FILE P.I. # 0009294
CSHPP000900294
Coweta County
GDOT District 3 - Thomaston
Chattahoochee Hills Regional Greenway Trail

SUBJECT **APPROVED CONCEPT REPORT**

DEPARTMENT OF TRANSPORTATION
STATE OF GEORGIA
LIMITED SCOPE PROJECT CONCEPT REPORT

Please find along with this letter the revised Concept Report for the Chattahoochee Hill Country Regional Greenway Trail System: Coweta County Pilot Segment, PI. 009294. This letter summarizes our responses to the review comments received on 05/31/2016.

1 05-001 **TYPICAL SECTION**
SCALE: NTS

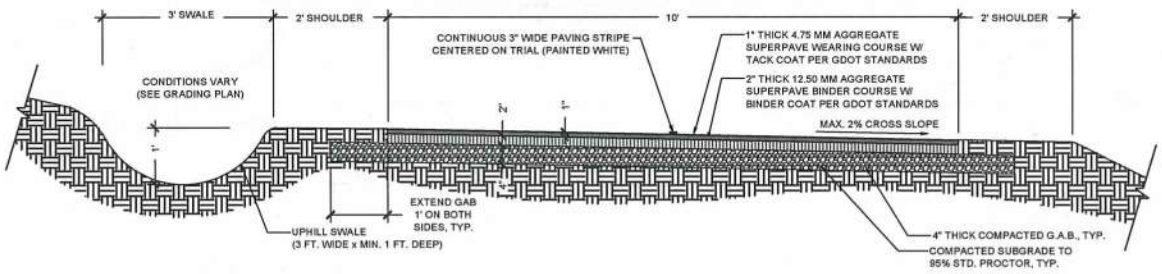
Under mainline design features, where were dimensions in the column "Standard*" taken from. The DPM does not included guidance for recreational trails."
   Response: The project will be designed according to AASHTO Guide for the Development of Bike Facilities. A statement was added under the mainline design features table that all dimensions were taken from the AASHTO Guide.
